## Determination 2017/031

# The code compliance of a proposed shower area in a new house at 24A Beechnest Drive, St Arnaud

**Figure 1: The bathroom**

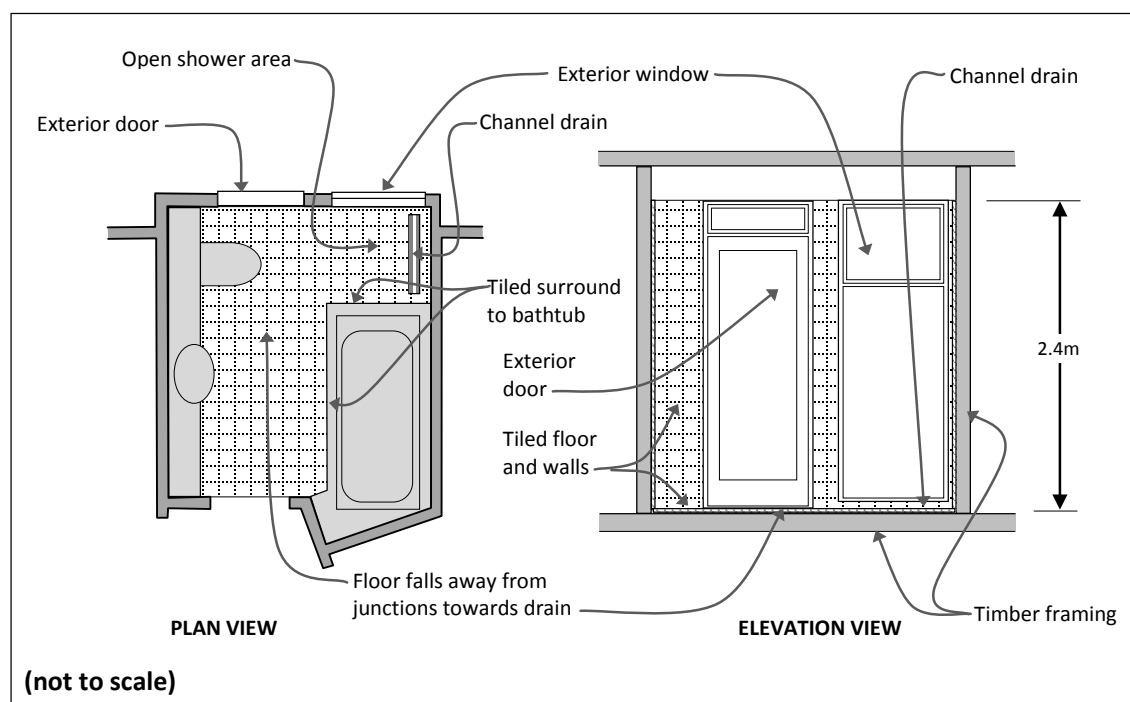
3.2.1 In a letter to the architect dated 13 February 2017, the authority required further information about various items, including the:

...alternative solution in respect of the full length window (reference WO7) being located in the external wall to the tiled (walk in) shower shown in the Bathroom.

3.2.2 The authority noted that the following was required (in summary):

- all material elements to be fully annotated on the bathroom details on WD14
- the manufacturer’s data sheet for the ‘continuous bandage’ noted on details
- expanded details of junctions between the membrane and window
- the manufacturer’s confirmation that the ‘waterproof membrane can be applied to, and provide an appropriate seal to, the aluminium window sections.’

**Figure 2: Simplified sketches of tile junctions based upon the architect's details**

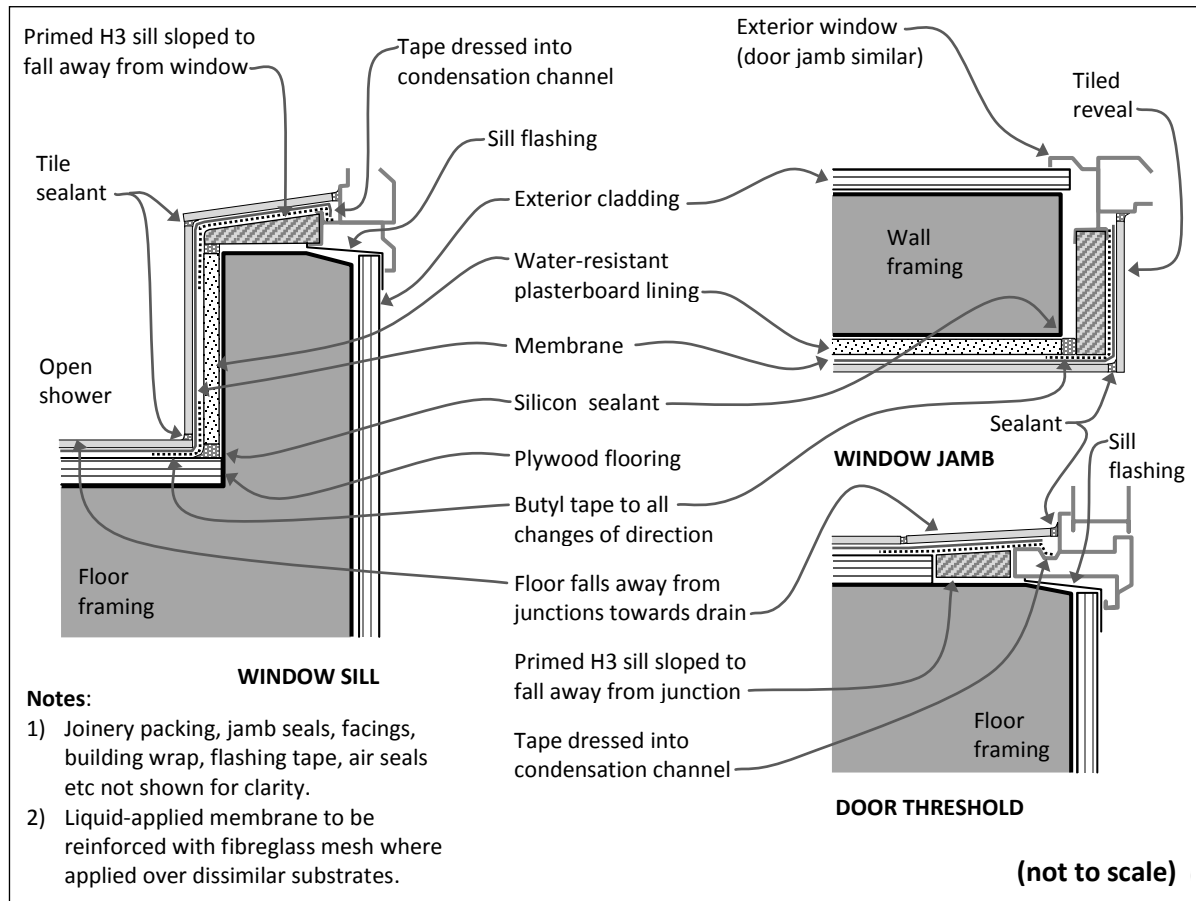
3.3.3 The authority reviewed the amended proposal and its internal checklist completed on 3 March 2017 rejected the alternative solution and recommended a determination be sought on the compliance for ‘both the window in the shower [and] the adjacent external door’. The reasons for the decision were noted as:

Multiple junctions between dissimilar materials, plus timber substrate.

Concerns compliance with NZBC Clauses E3.1(a), E3.2(a) and (c), E3.3.4, E3.3.5, E3.3.6, plus Acceptable Solution E3/AS1, Section 3 (3.1, 3.1.1, 3.1.2, 3.3.2, 3.3.1 and 3.3.2) not achieved including to meet durability requirements NZBC B2 (B2.1, B2.2, B2.3.1(a) and (b), B3.3.2)

- (1) Timber substrate construction (not concrete)
- (2) Multiple junctions
- (3) Greater dissimilar materials.

- 6.3.2 The shower includes an under-tile waterproofing membrane applied over butyl junction tape that falls away from vulnerable junctions as shown in Figure 2. This junction design directs any moisture away from the junctions or into the joinery condensation channels from the joinery surfaces. Such channels are typically designed to collect any condensation that runs down the inside of the glass and frame, with holes to direct the water to the outside. Any moisture breaching the tile sealants and underlying membrane system would also fall into these channels and be directed to the outside.

- 6.3.3 Should the first barrier to water ingress fail, the proposed system has the following mechanisms to direct any internal moisture to the exterior:

- the falls away from the vulnerable junctions, towards the channel drain
  - the membrane system dressed into the condensation channels to the sills
  - the sill tray under the window and door sills

- the wrapped and taped timber framing beneath the joinery openings.
- Any other failure of the joinery's waterproofing performance (i.e. failure of glazing gaskets or aluminium mitre junctions) would lead to the same drainage mechanisms from the condensation channels being brought into play.

- 6.6.1 Taking account of the available evidence, I consider there is sufficient evidence to establish on reasonable grounds that the proposed shower area considered in this determination will comply with Clauses E3 and B2 of the Building Code.
- 6.6.2 Maintenance of the tile sealant will be an important factor in ensuring ongoing performance of the system as a whole and this is the responsibility of the owners. The surface finishes, joints and sealants are readily observable and repairable.
- 6.6.3 I have also noted that the documentation and some information provided to support the tiled membrane system as an alternative solution is inconsistent in a number of areas, which appear to be fairly minor. I leave these to be resolved as part of the normal consenting process.

- 7.1 In accordance with section 188 of the Building Act 2004, I hereby determine that the detailing to the proposed shower area will comply with Clause E3 and Clause B2 of the Building Code.
